PROPOSED CRECHE & COMMUNITY FACILITY
AT CUIL DUIN AVENUE, CITYWEST,
CO. DUBLIN

RESPONSE to REQUEST for FURTHER INFORMATION
Planning Application Register Reference SD22A/0398

22262-2-D02

Fig 03: extract from dwg. no. 22262-T-102

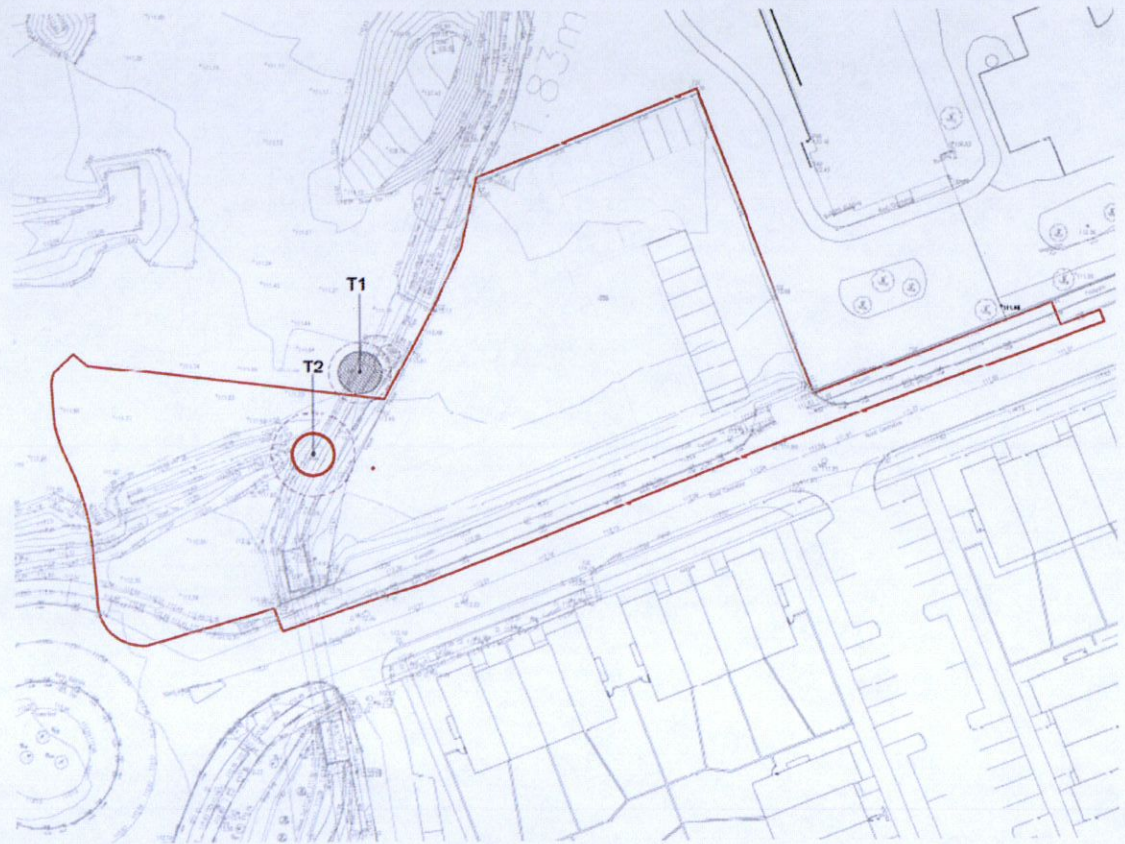
5.(i) To ensure the protection of trees to be retained within the site, the developer shall implement all the recommendations pertaining to tree retention, tree protection and tree works, as detailed on the submitted Tree Protection Plan. The arborist shall carry out a post construction tree survey on the condition of the retained trees. A completion certificate shall be signed off by the arborist when all permitted development works are completed and in line with the recommendations of the tree report. The certificate shall be submitted to the Public Realm Section for written agreement upon completion of the works. The developer shall also be made aware of their obligations to constantly assess and survey the trees after construction because of the potential impact and the age/condition of these trees as outlined in the tree survey. Reason: To ensure and give practical effect to the retention, protection and sustainability of trees during and after construction of the permitted development.

(ii) No drainage or service runs (including cables, pipes or similar services) shall be laid beneath the canopy of any tree identified for retention or within any fenced protection zone unless otherwise agreed in writing by the local planning authority.

(iii) The applicant shall submit a detailed Tree Survey for the subject site.

- drawings number 22262-T-101 & 102 - Tree Classifications & Constraints and Arboricultural Impact Assessment
- 22262-T-D01 Tree Survey

A tree survey has been carried out on 16th March 2023 where has been identified that the existing tree inside site is infected with Ash Dieback, reason why the retention it is not possible. However, a tree protection measure is not required for the existing tree outside the site boundary shown as retained. It has been identified that that this tree is good value for biodiversity.
